Proposal for Supplement 1 to the 05 series of amendments to Regulation No. 48 (Uniform provisions concerning the approval of vehicles with regard to the installation of lighting and light-signalling devices)

To simplify and clarify requirements for the headlamps initial aiming, aiming tolerances and making it independent from the light source used in the headlamp.

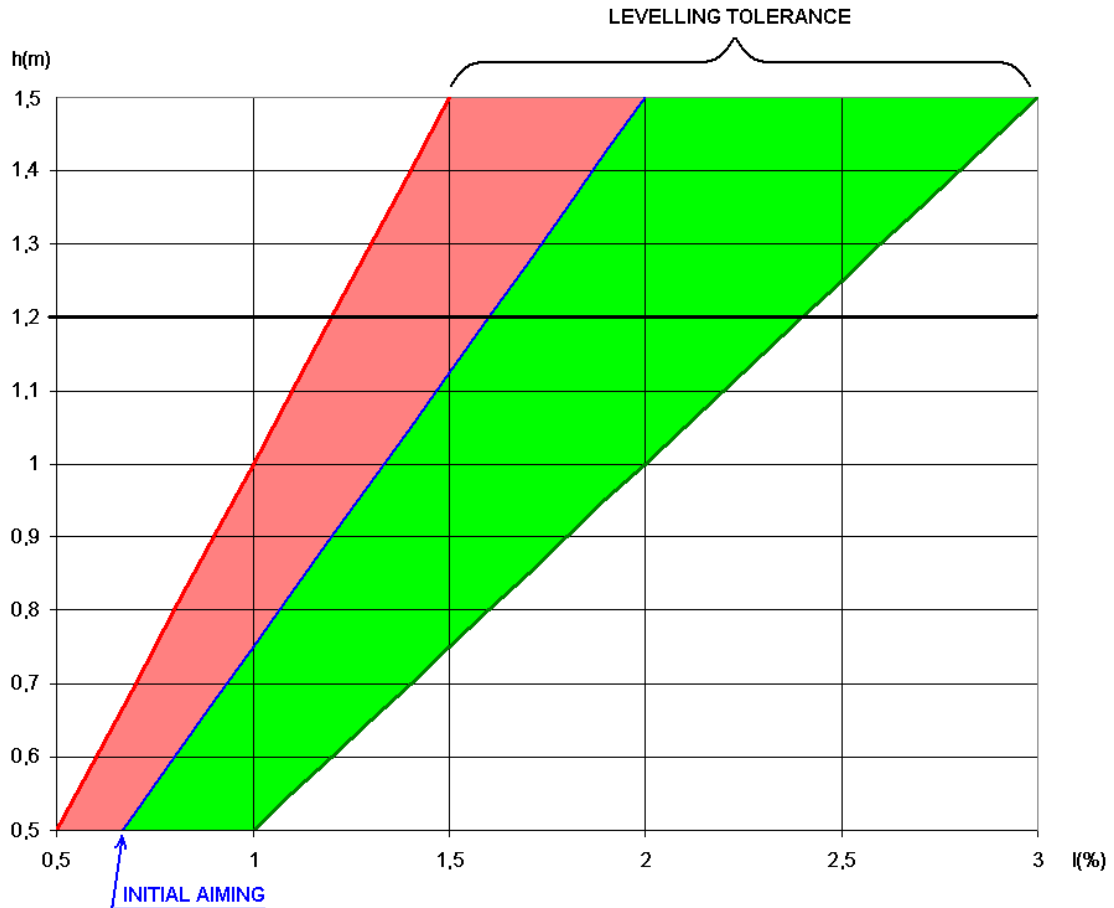
"6.2.6.1.2. Depending on the mounting height in metres (h) of the **dipped-beam headlamp reference axis the vertical inclination of the cut-off of the dipped beam, (in the direction of the reference axis) measured on the unladen vehicles, shall have the value of initial aiming for which the horizontal part of cut-off crosses the surface of flat horizontal road at the distance of 75 m from the headlamp.**

The aiming limits under all the static conditions of Annex 5 should be such that the distance of crossing of vertical part of cut-off with road surface shall remain between [50m] and [100m].

limits: ~~between 0.5 per cent and 2.5 per cent~~
initial aiming: ~~between 1.0 per cent and 1.5 per cent~~

limits: ~~between 0.5 per cent and 2.5 per cent~~
initial aiming: ~~between 1.0 per cent and 1.5 per cent~~

limits: ~~between 1.0 per cent and 3.0 per cent~~
initial aiming: ~~between 1.5 per cent and 2.0 per cent~~

limits: ~~between 1.0 per cent and 3.0 per cent~~
initial aiming: ~~between 1.5 per cent and 2.0 per cent~~

The above limits and the initial aiming values are summarized in the diagram below.
